Groundwater Transfer Review Summary Form

Transfer/PA # T- 14449

Application: T-14449

Applicant Name: City of Banks

Cross-section 1: N-S, proposed APOA “AN Well” and “AS Well” and WASH 77444, WASH 50693**Cross-section 2: W-E, proposed APOA “AN Well” and WASH 79189, WASH 56924**

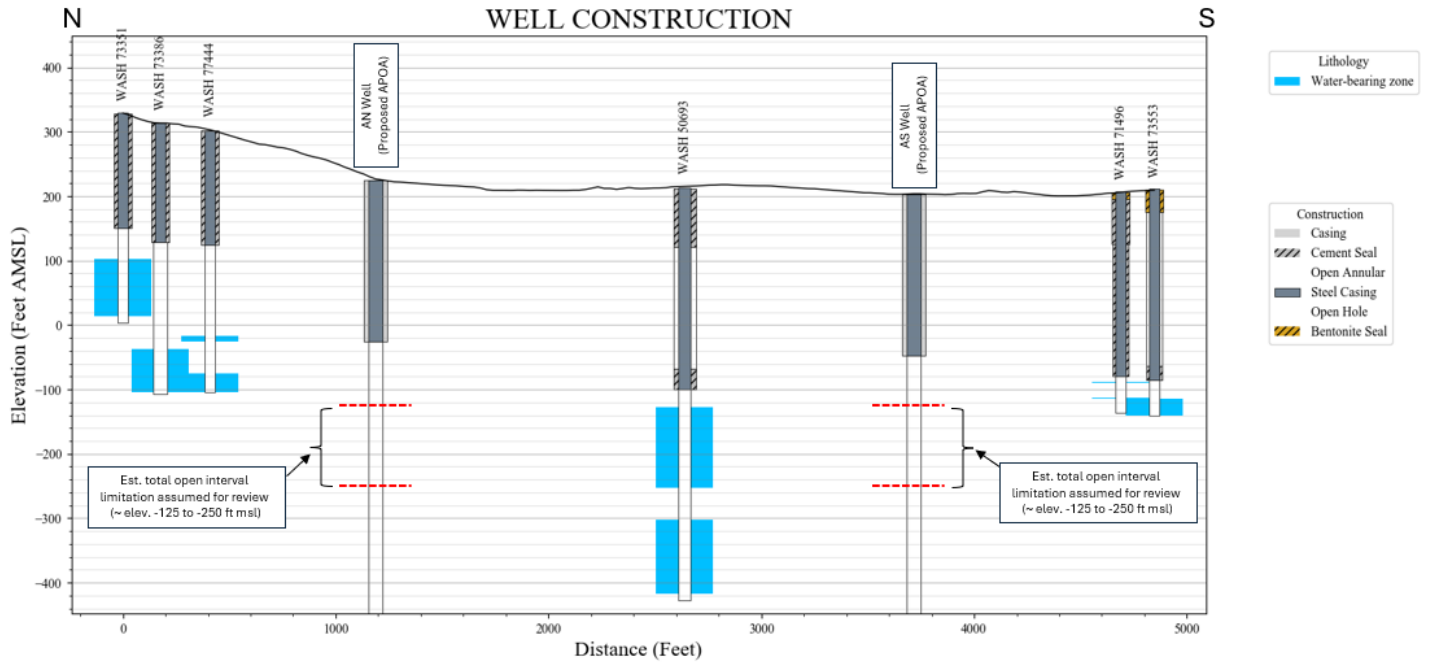
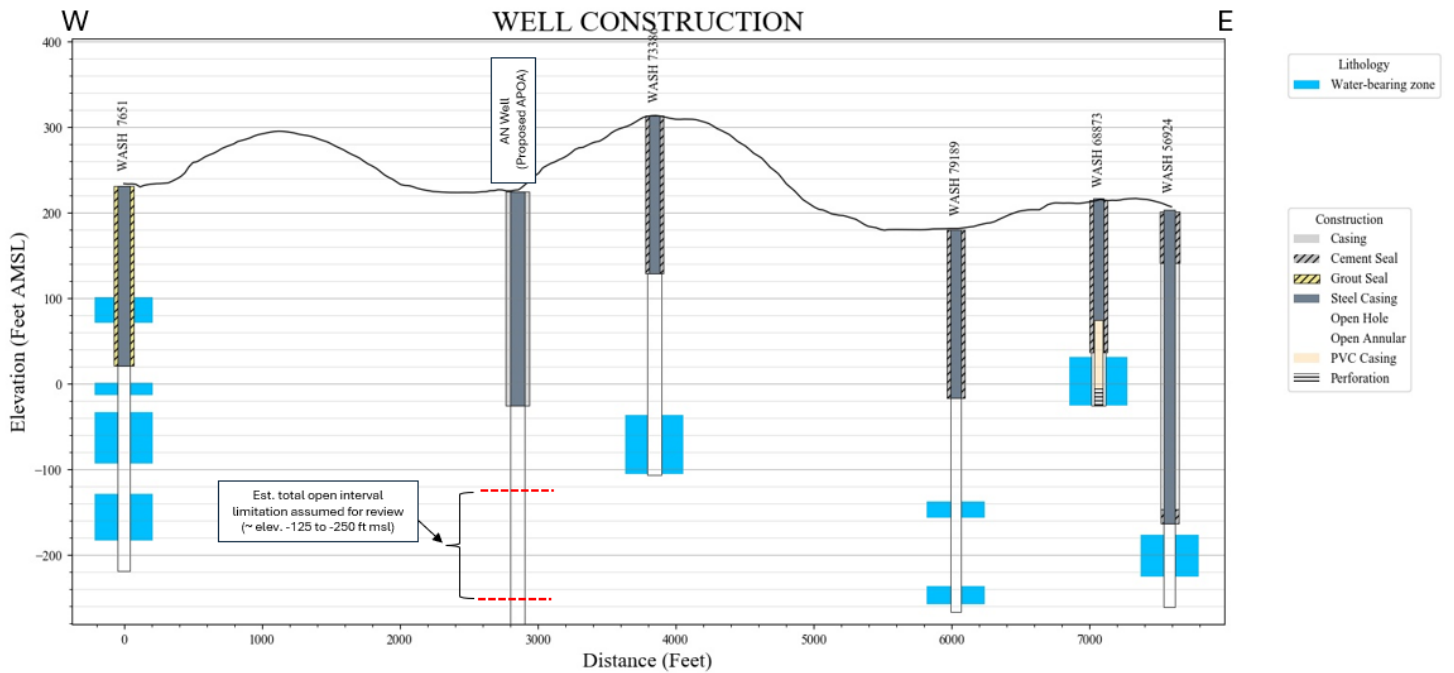
The key WBZ in WASH 77444 (between elev. ~-20 to -105 ft msl) is above the assessed WBZ in the “AN Well” (between elev. ~-125 to -250 ft msl); nearby WASH 73386 is similarly completed (see attached cross-section 1). However, because WASH 77444 and WASH 73386 are located at a higher ground surface elevation than the “AN Well” location, it is possible that the WBZ in the two locations is approximately the same basalt interflow grouping, but has been vertically offset by faulting between the two locations (the fact that existing geologic maps do not show a fault at this location does not preclude the possible existence of one). Faults typically truncate basalt interflow zones/WBZ, which would reduce or eliminate hydraulic connection between wells on either side of the fault. Whether or not a fault is present at this location, it is likely that there is **not** an efficient hydraulic connection (or any whatsoever) between the “AN Well” and WASH 77444, WASH 73386, or other nearby wells of similar completion, and thus those wells are unlikely to be injured due to the proposed use of the “AN Well.”

Farther to the east, the completion depths and open intervals of other wells are similar to authorized POA WASH 7651, in particular WASH 79189 and WASH 56924. These wells obtain groundwater from approximately the same primary WBZ present in WASH 7651 and are thus more likely to be adversely affected by pumping at the “AN Well” location (see attached cross-section 2).

**Theis Drawdown Analysis, Proposed APOA "AN Well" to WASH 79189****Theis Time-Drawdown Worksheet** v.5.00

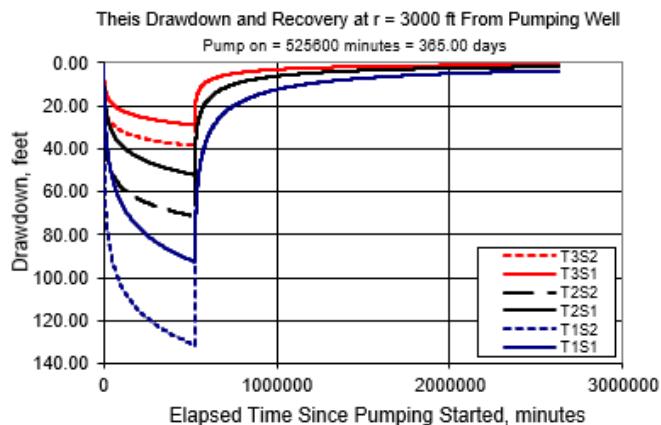
Relative to the location of authorized POA WASH 7651, the proposed location for the “AN Well” is about 2700 feet nearer to WASH 79189. The results of the Theis interference analysis indicates that additional interference in WASH 79189 could potentially range from about 10 to 20 feet due to pumping the maximum rate (0.67 cfs) 24/7/365 from the “AN Well” (see attached Theis analysis results). Limited water level data from other nearby wells (WASH 56924) indicates that the static water level in WASH 79189 likely ranges from about elevation 180 to 200 ft msl, which would provide roughly 200 feet or more of available drawdown in both it and existing wells of similar completion (i.e., those wells that fully penetrate the upper WBZ present in WASH 7651). This approximate range of available drawdown should be sufficient to support ongoing usage of these wells with the change proposed by this application (i.e., the change will not prevent those wells from receiving the groundwater to which they are legally entitled).

Cross-section 3: N-S, proposed APOA “AS Well” and WASH 50693, others

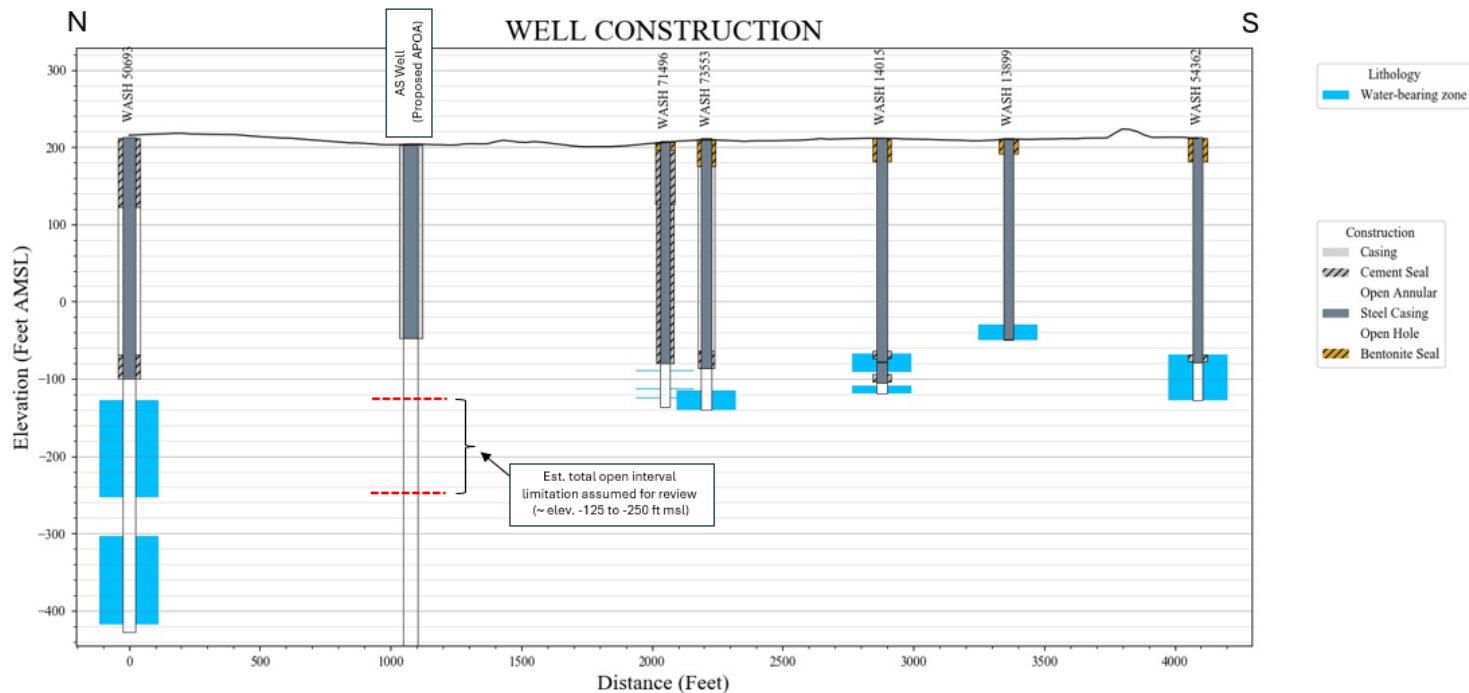
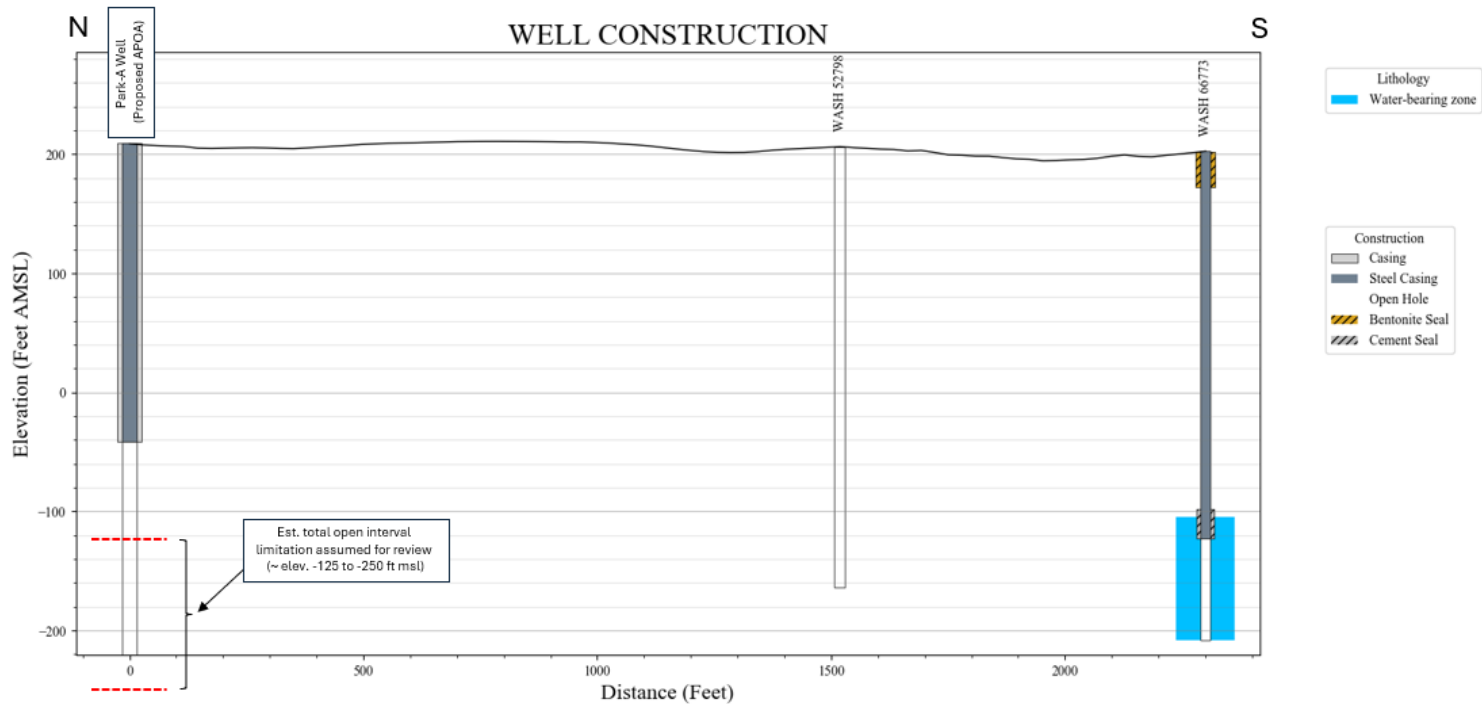
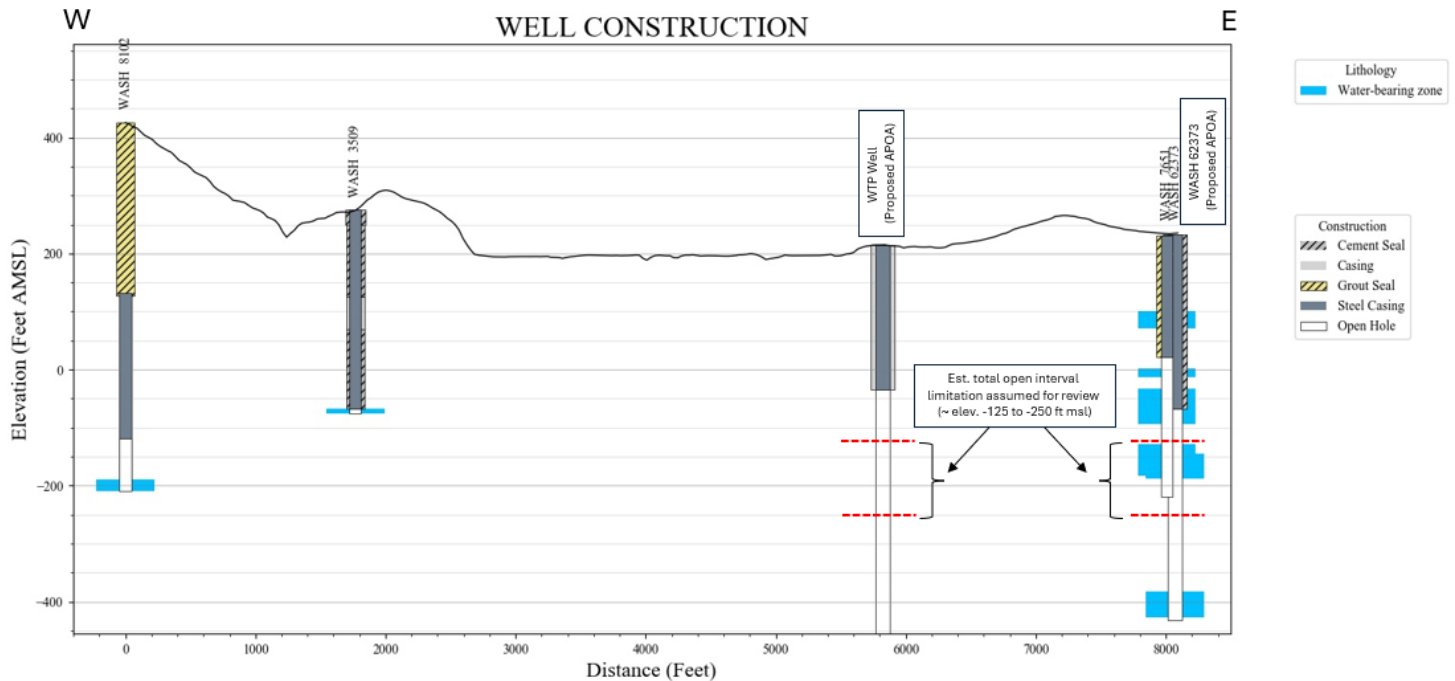
Relative to the location of authorized POA WASH 7651, the proposed location for APOA “AS Well” is about 3600-3800 feet nearer to WASH 71496, WASH 73553 and several other domestic wells in the area. However, all of these existing wells are relatively shallow with the borehole bottoms very near, or just above, the recommended casing/seal depth elevation for all of the proposed APOA (at about -125 ft msl) (see attached cross-section 3). It is also notable that some of these same nearby wells only access the uppermost portions of the CRBG in this area, i.e., likely the flow top at the contact between alluvial sediments and the underlying basalt, and do not extend deeper into the same or another WBZ (such wells are considered by OWRD to be “alluvial aquifer” wells and not “CRBG aquifer” wells). Because these existing wells do not fully penetrate the upper WBZ present between approximately elevation -125 to -250 ft msl, or are considered to be “alluvial wells” despite partial penetration into the upper basalt unit, an injury determination would not be made due to the proposed use of the “AS Well.”

Theis Drawdown Analysis, Proposed APOA “WTP Well” to WASH 8102/8909

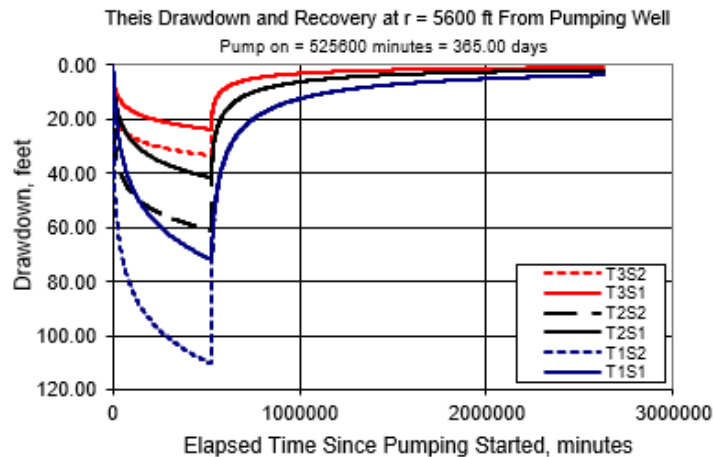
The results of the Theis interference analysis indicates that WASH 8102/8089 could potentially experience about 5 to 10 feet of additional drawdown due to pumping the maximum rate (0.67 cfs) 24/7/365 from the “WTP Well” (see attached Theis analysis results). It is unlikely that this small additional drawdown estimated for WASH 8102/8089 would prevent it or other similarly-constructed wells in the area from receiving the groundwater to which they are legally entitled.
